6.4 [21-25 THE AVENUE BALACLAVA \(PDPL/01434/2021\)](#)

LOCATION/ADDRESS: 21-25 THE AVENUE BALACLAVA VIC 3183

1. PURPOSE

- 1.1 To determine an application for the construction of a three-storey apartment building containing 34 dwellings over one basement level of car parking and a front fence exceeding 1.5 metres in height.

Figure 12: bedroom windows facing ramp

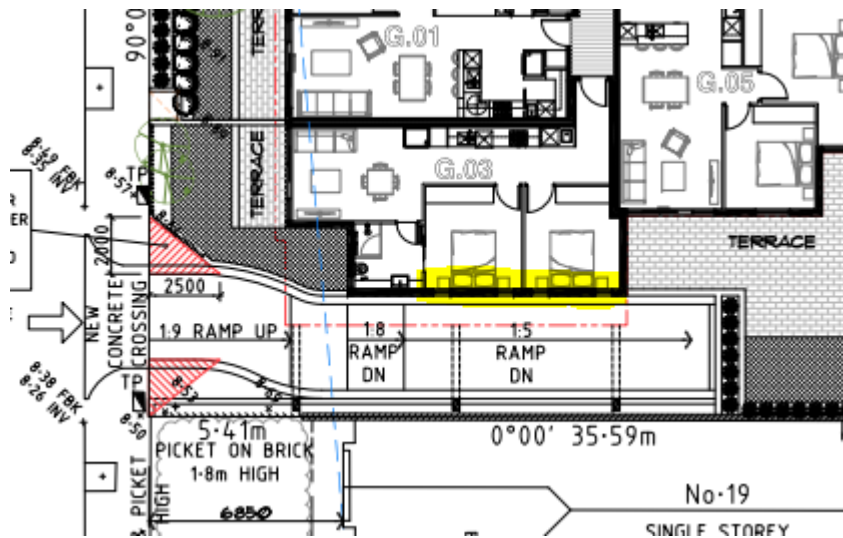
- 11.5.7 At ground level Apartment G.03 contains two bedroom windows that front onto the vehicle ramp. This is a poor amenity outcome for future occupants. The figure below shows the windows highlighted yellow.

11.5.8 The discussion plans resolve this concern by changing the layout of the apartment into a one bedroom dwelling with a re-orientated window away from the ramp.

Figure 14: Apartment G.04 living area shown yellow

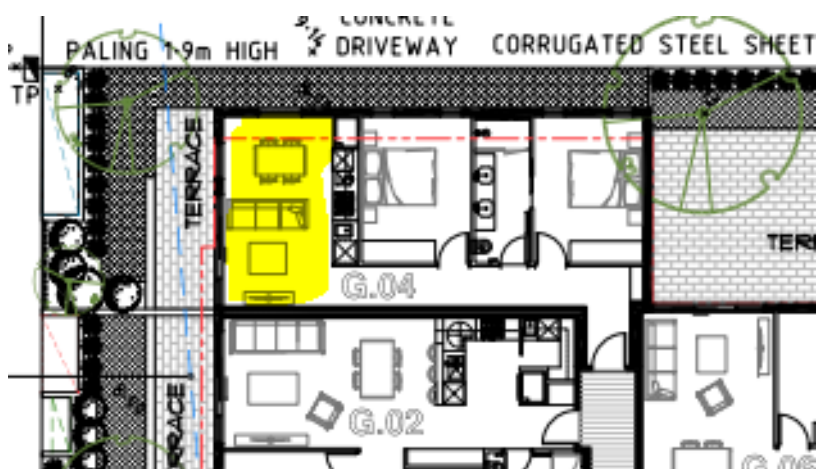
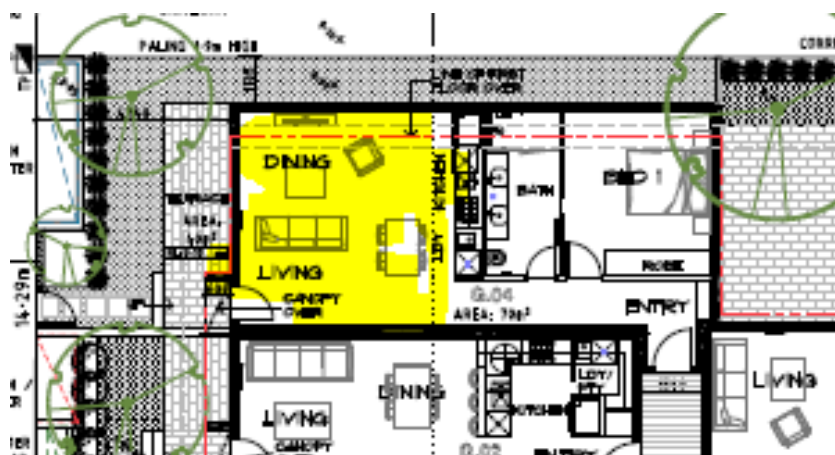
11.5.9 Apartment G.04 is a two bedroom apartment that contains a living area smaller than the bedrooms. This does not comply with the functional layout standards of Clause 55.07.

11.5.10 The discussion plans resolve this concern by enlarging the living area and making the apartment one bedroom instead of two.
